ADDENDUM NO. 1

To Project Bidding Documents for:
TV-23 Bio-Tech Classroom
Compton Community College

tBP Project. No. 21105.00

tBP/ARCHITECTURE

drawing no.:
P1-1
 drawing of

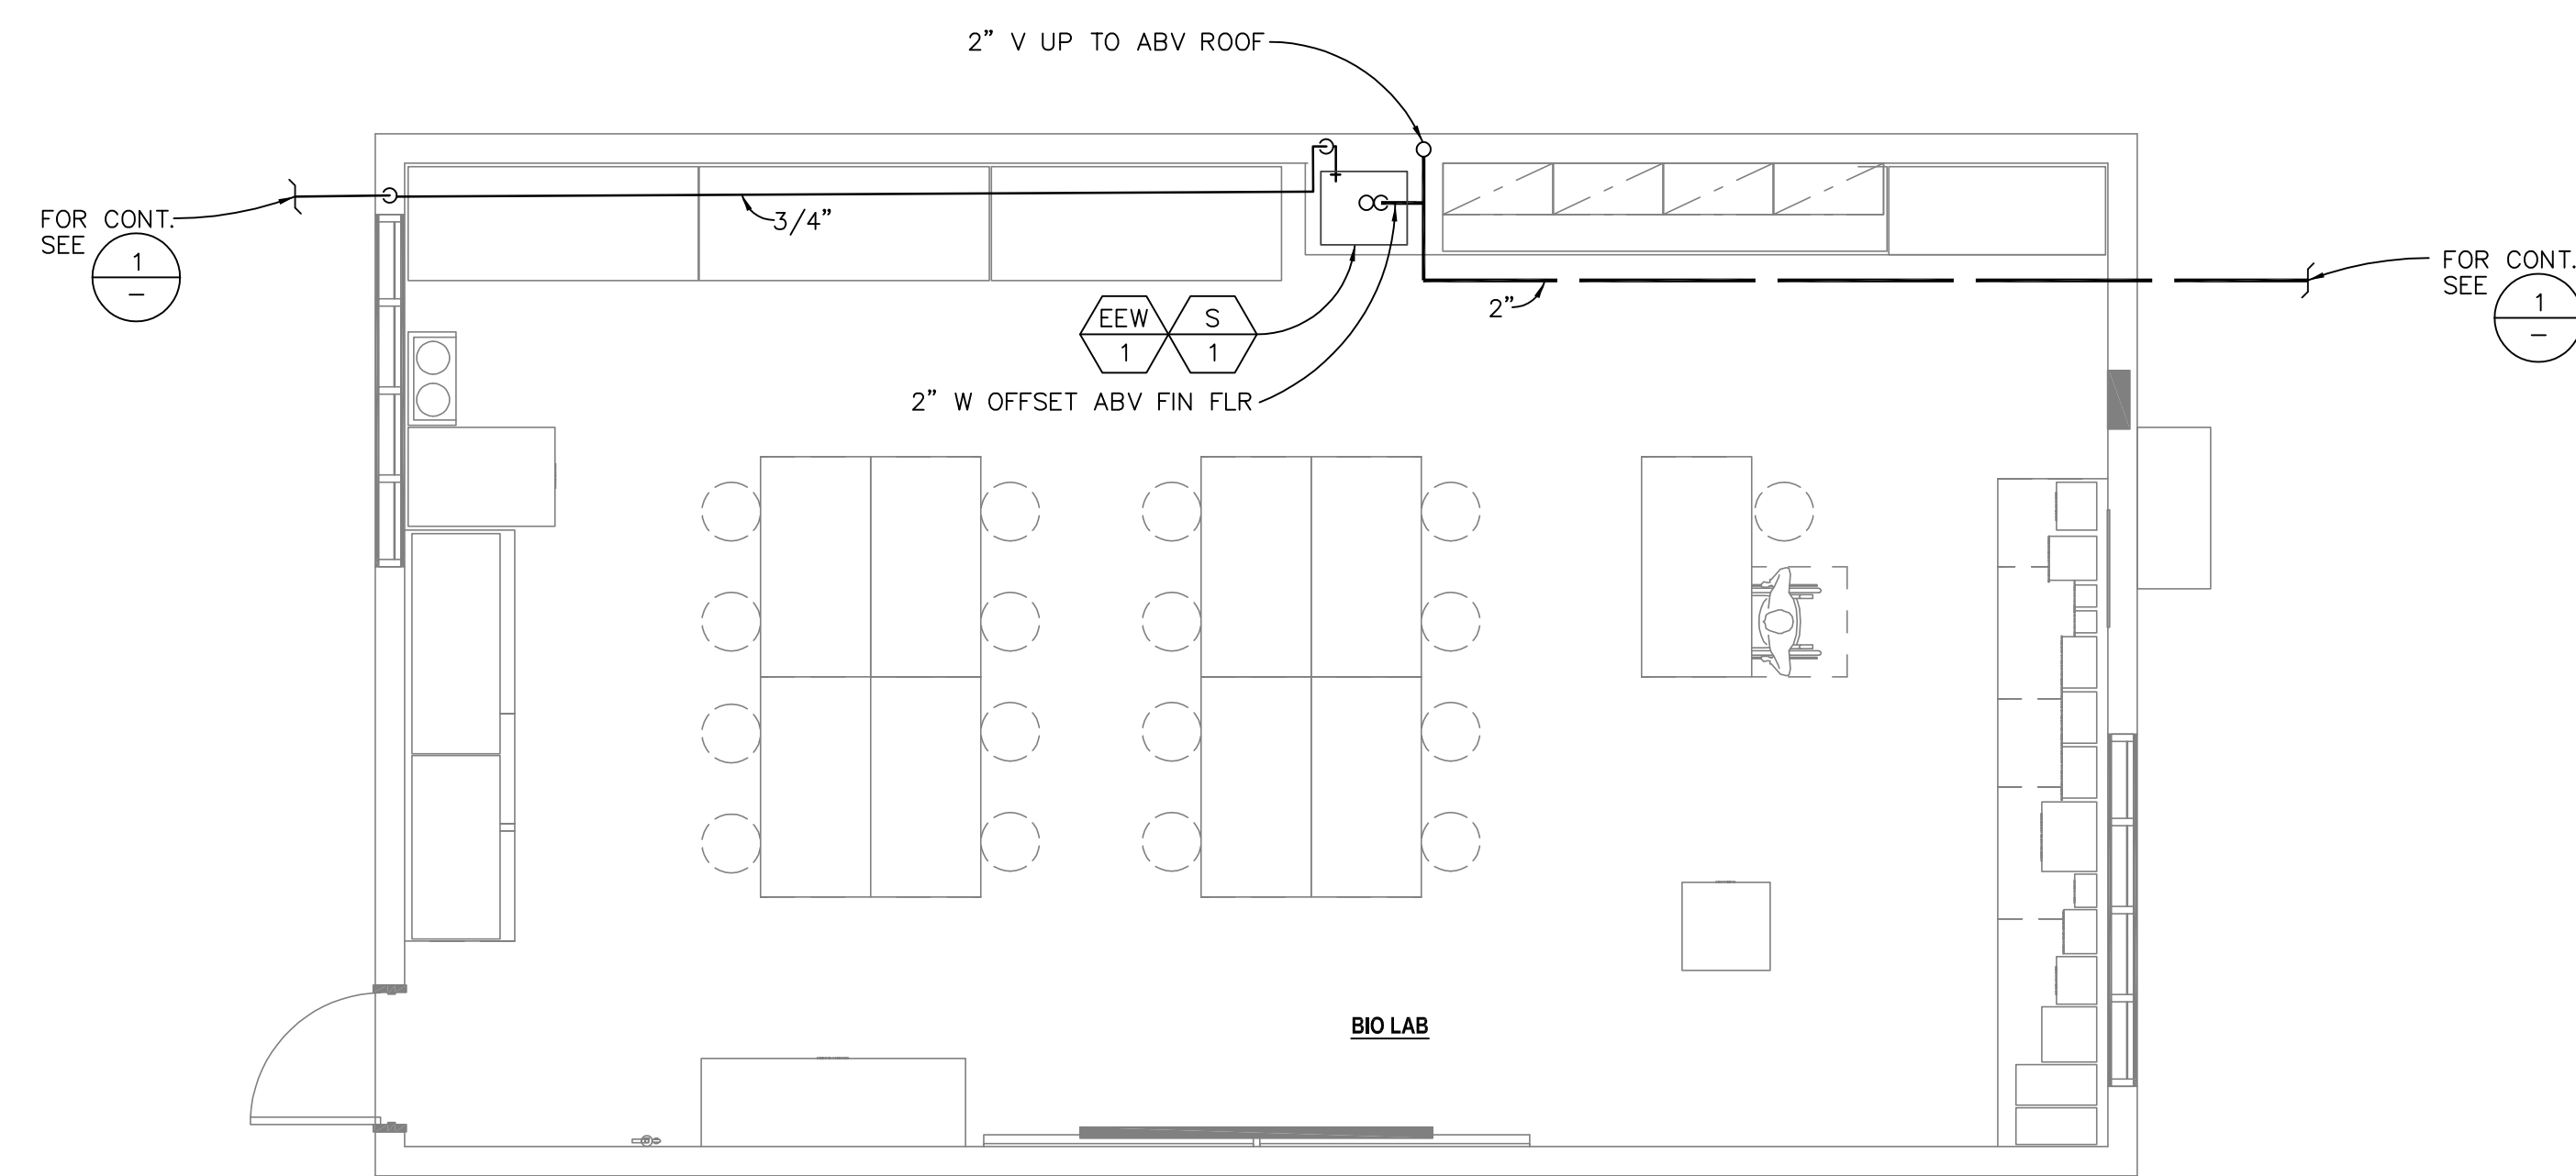
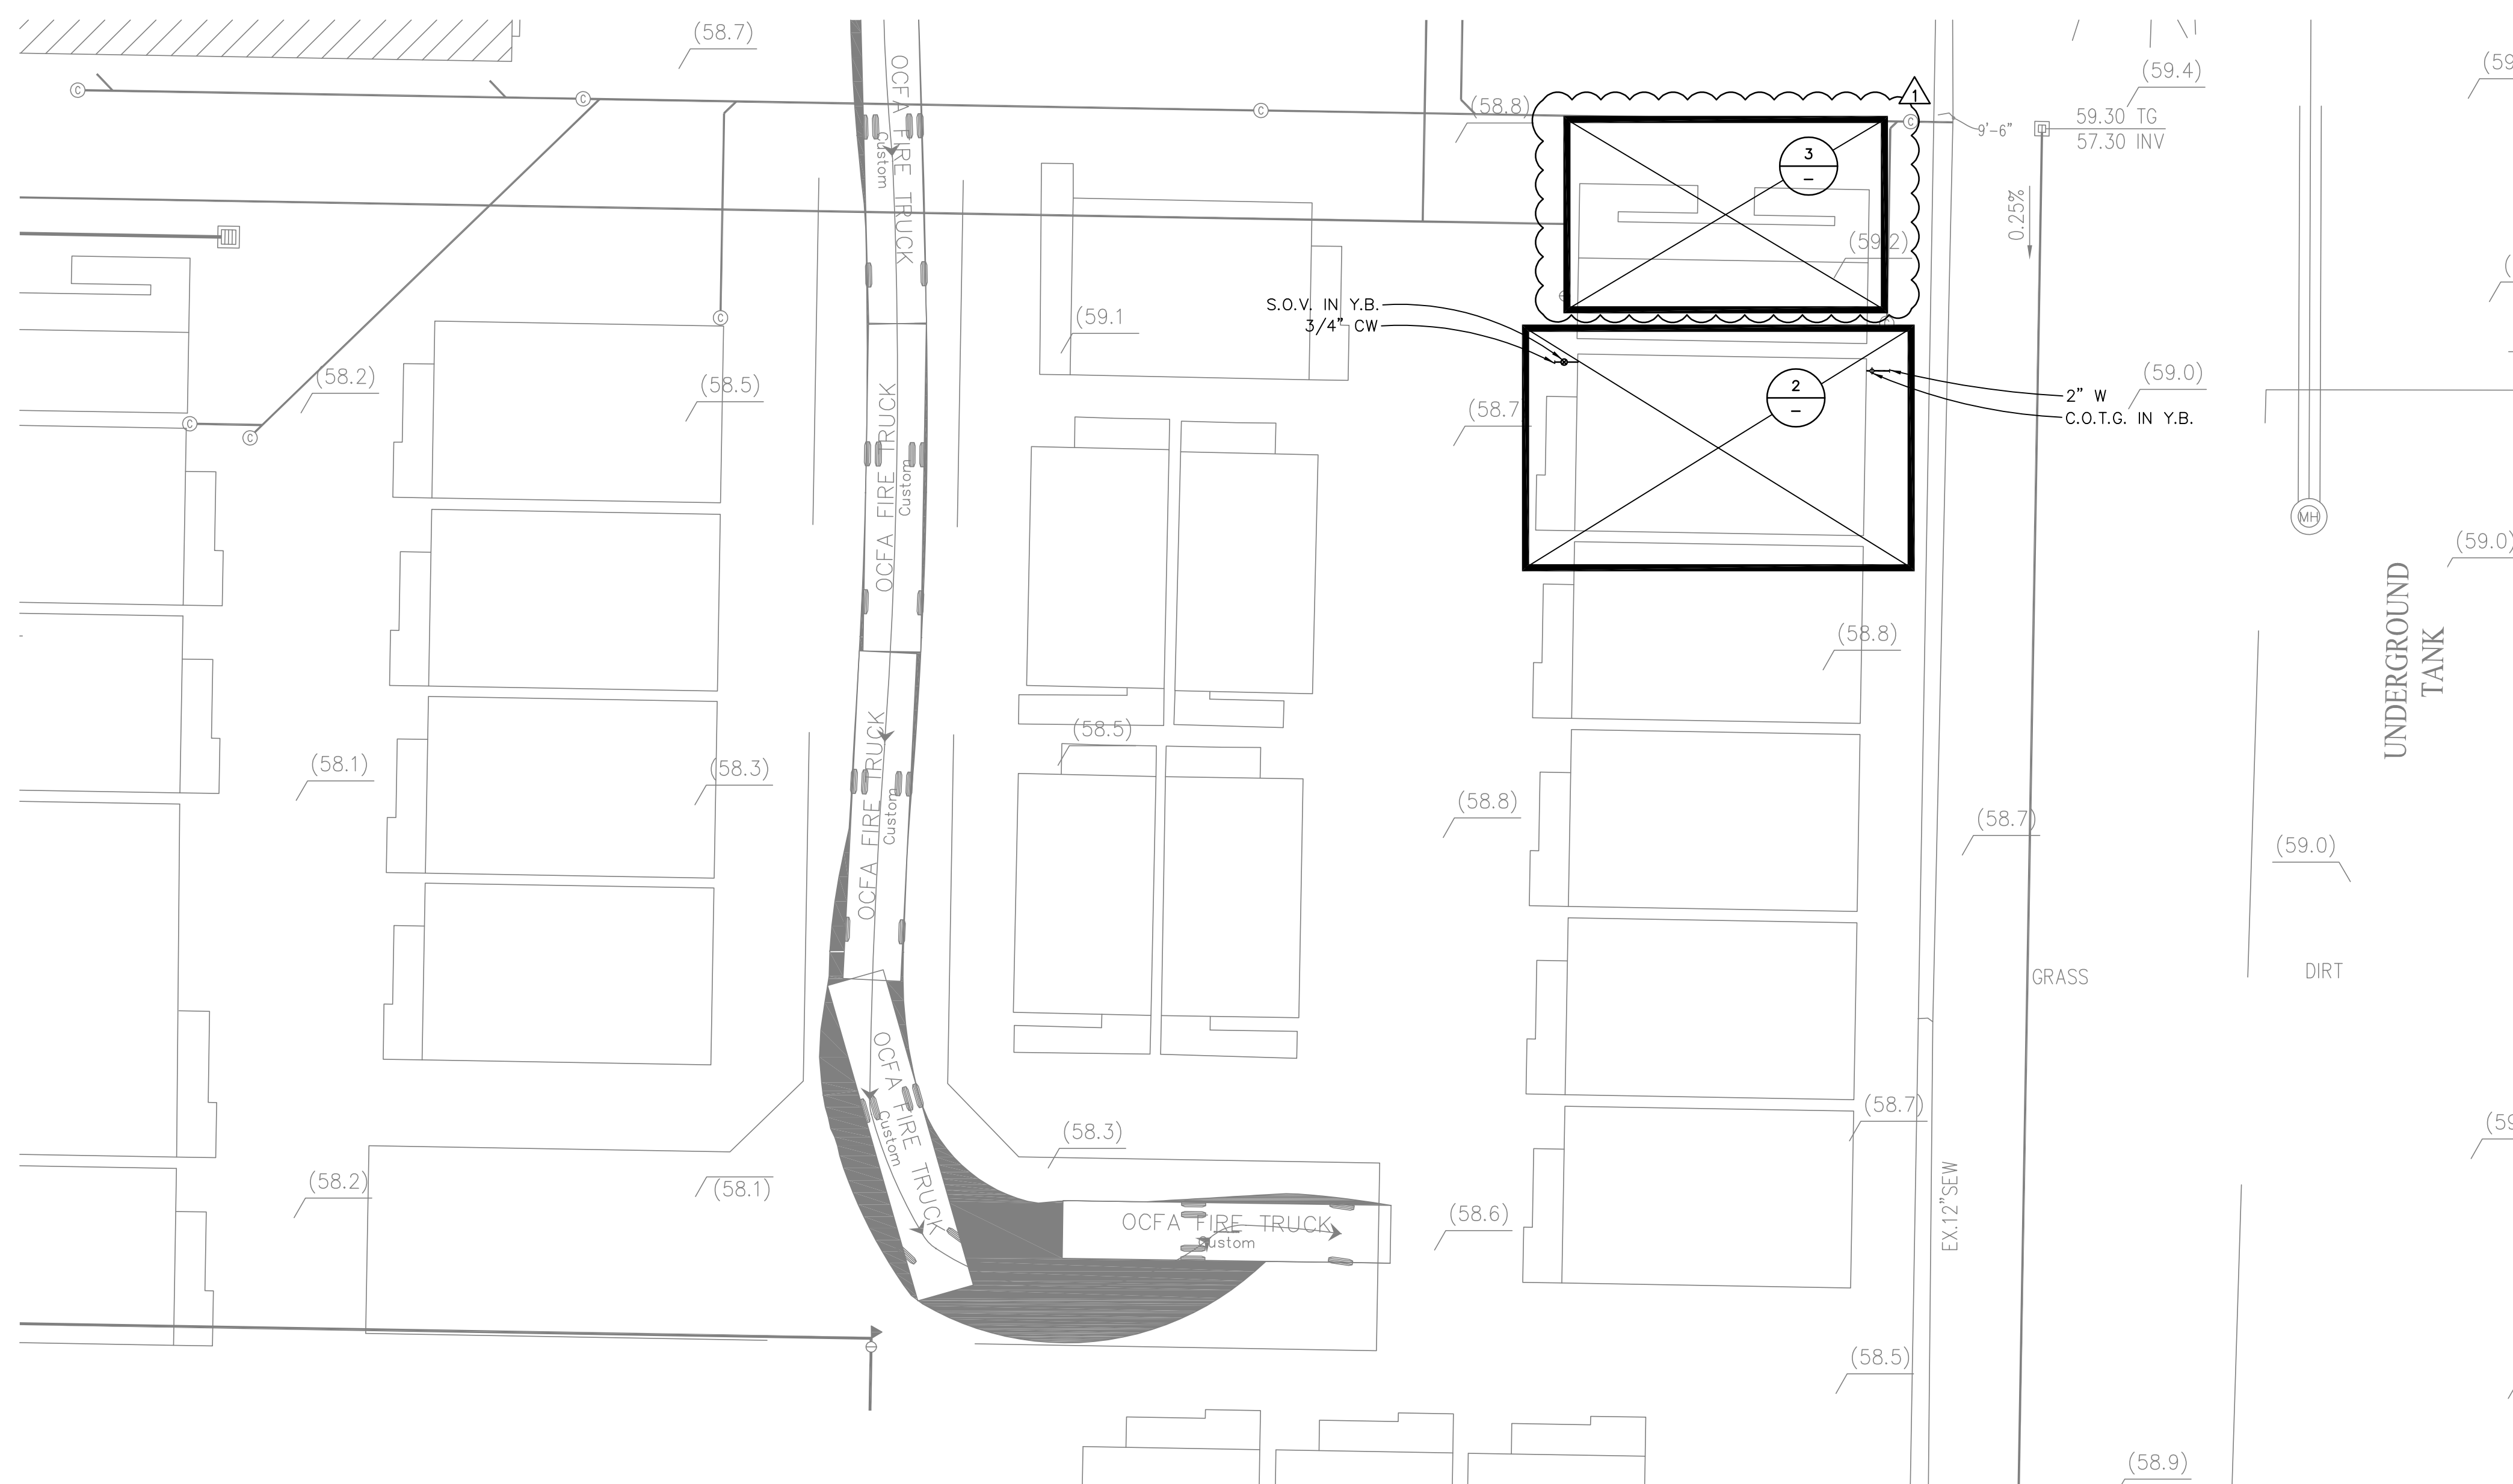
1. SHEET T-2 **SHEET INDEX AND GENERAL INFORMAITON** - Drawing List Architectural sheets replace D-3 by A-3
2. SHEET AS-1-- **ENLARGED SITE PLAN** Added detail for parking sign, added notes clarifying scope at ADA parking Relocation of drinking fountain is shown. **See attached revised sheet.**
3. SHEET A1-1 **FLOOR/CEILING & INTERIOR ELEVATIONS** Corrected Construction Notes Added clear wire mold location, clarifying notes, 75% demo of the wall paneling drywall. IDF location. **See attached revised sheet.**
4. SHEET A-3 DETAILS. Removed one detail added and updated Drinking fountain relocation and details. **See attached revised sheet.**
5. SHEET P1-1 PLUMBING FLOOR AND SITE PLAN Relocation of drinking fountain was

added. **See attached revised sheet.**

drawing no.:
E1-1
drawing of

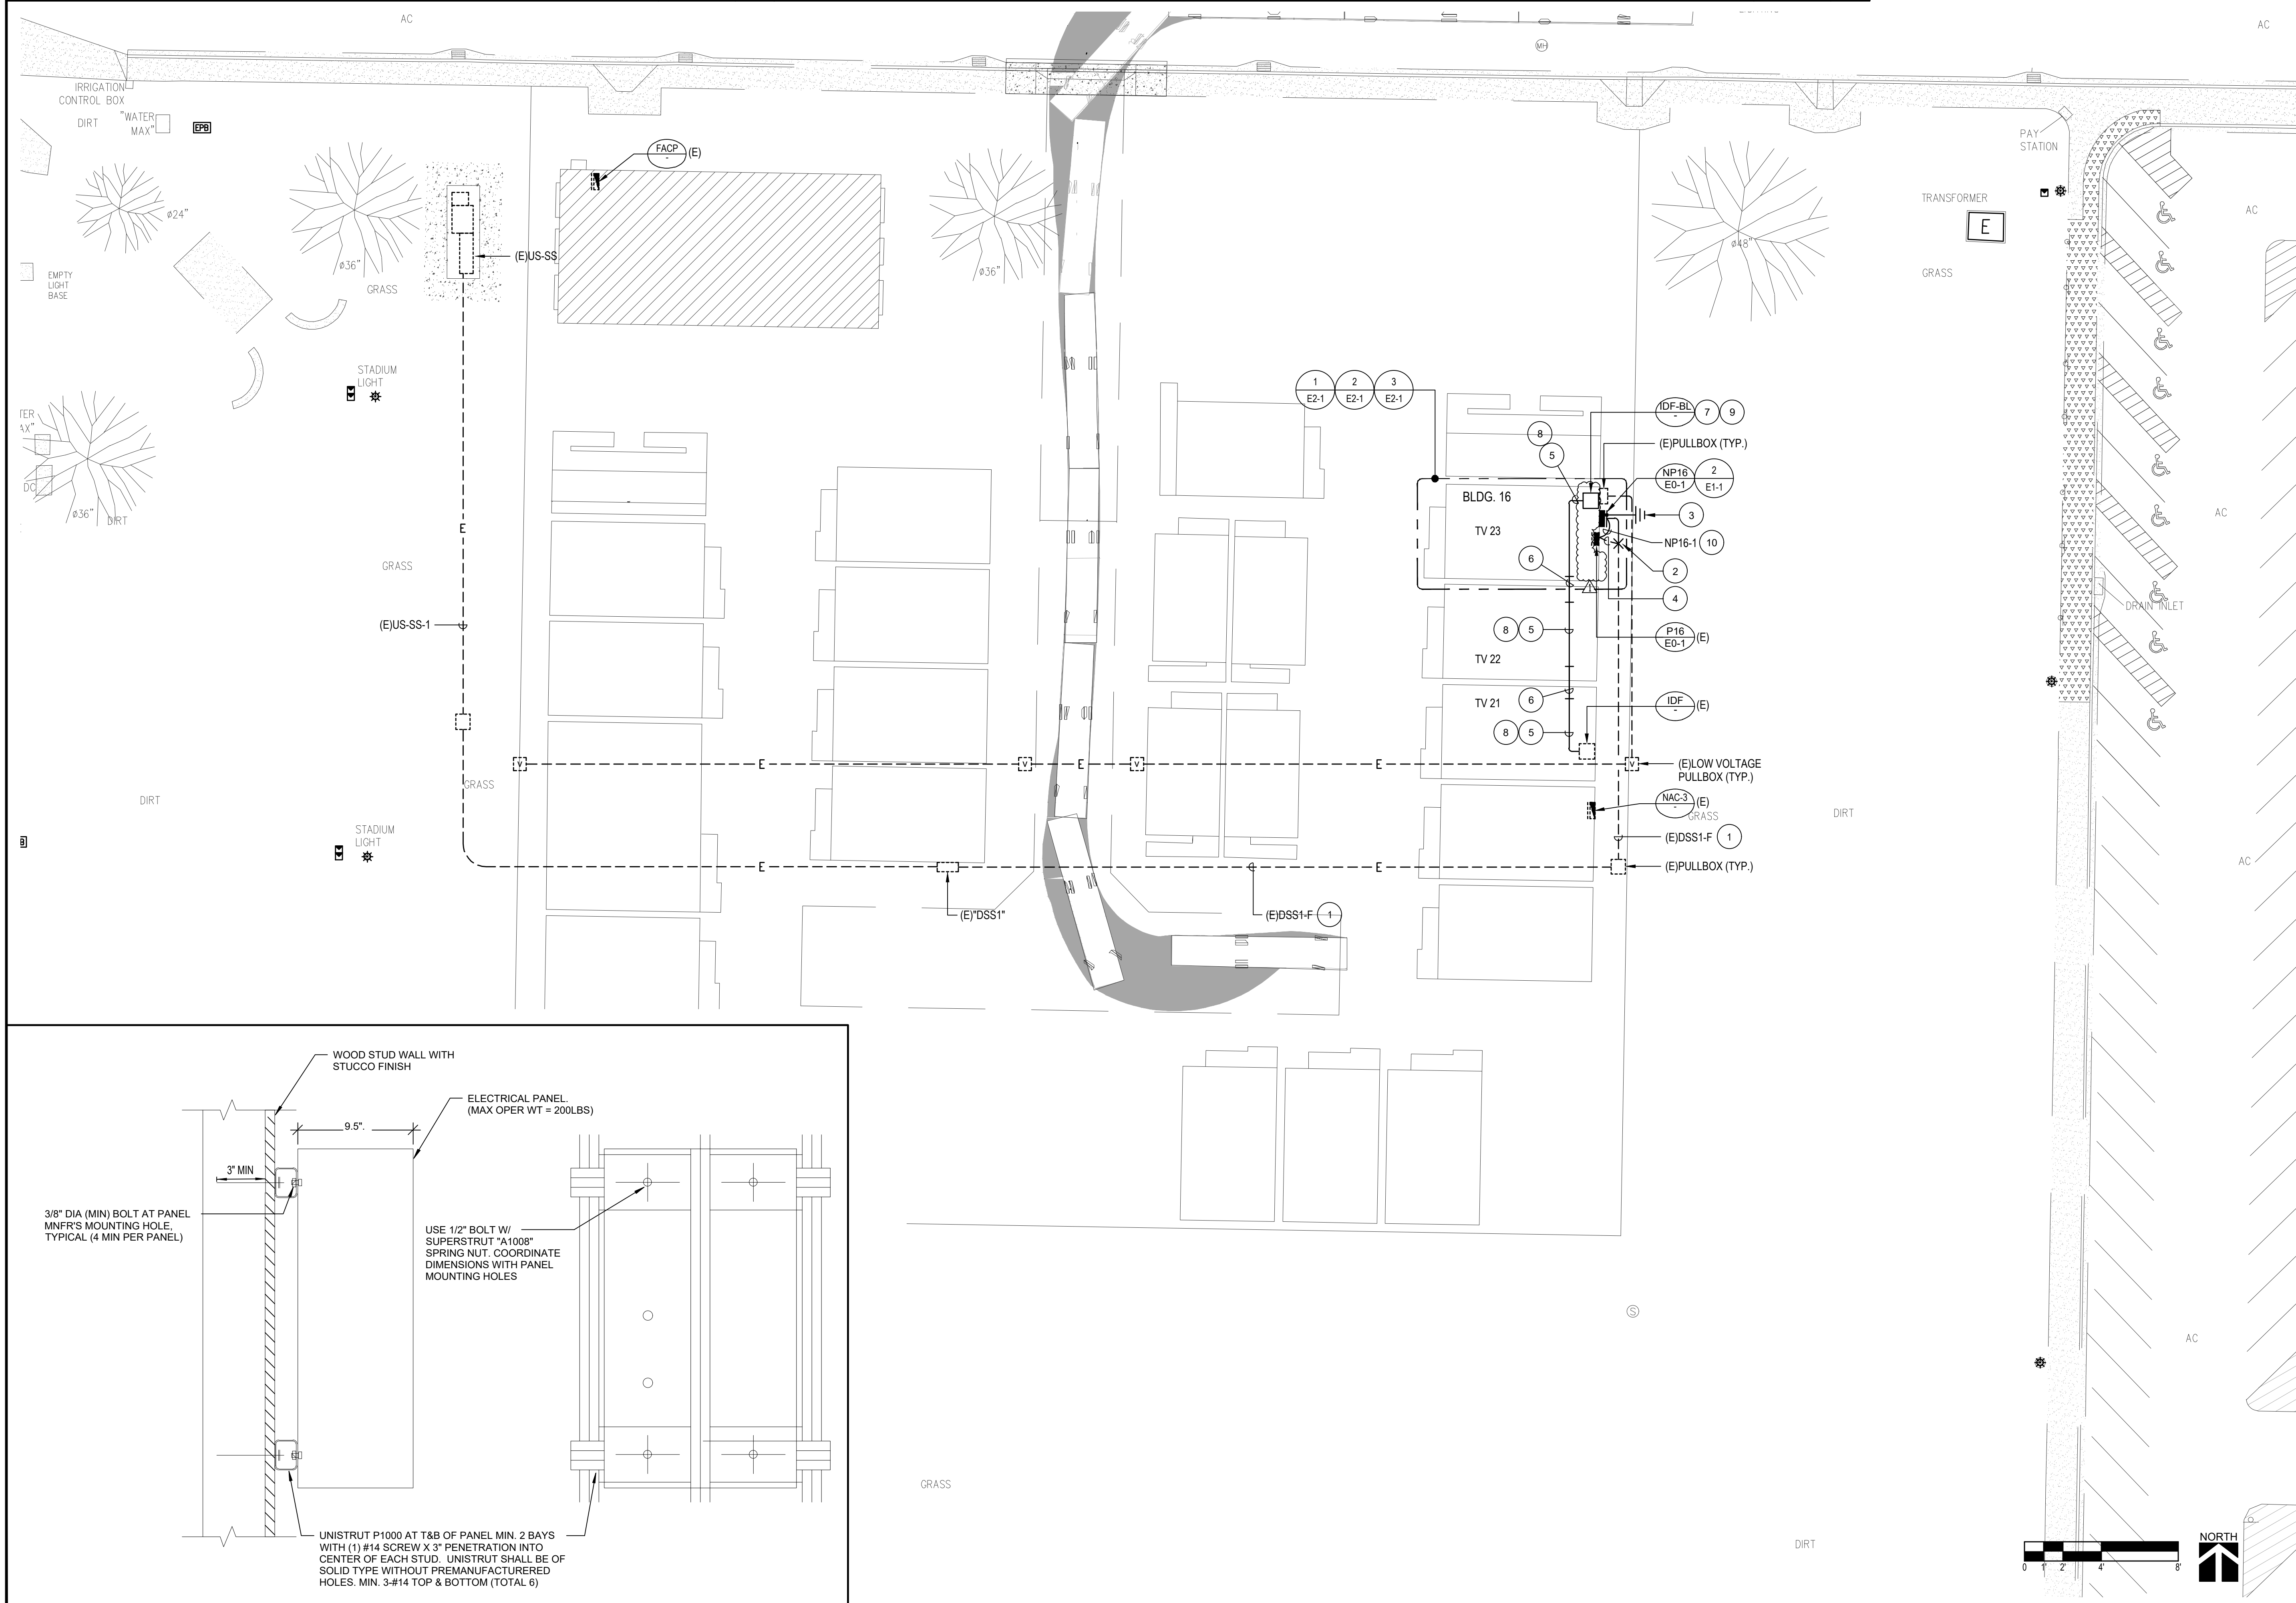
6. SHEET E0-1 **See attached revised sheet.**
 - a. Revised floor box outlet symbol per attached revised Drawing E0-1.
 - b. Revised panel schedule "NP16" per attached revised Drawing E0-1
7. SHEET E1-1 **See attached revised sheet.**
 - a. Revised location of IDF cabinet per attached revised Drawing E1-1.
8. SHEET E2-1 **See attached revised sheet.**
 - a. Revised location of IDF cabinet per attached revised Drawing E2-1.
 - b. Extended raceways per attached revised Drawing E2-1.
 - c. Deleted three (3) receptacles on north wall of the room per attached revised Drawing E2-1.
9. ENGINEER CONSTRUCTION ESTIMATE \$180,000.00
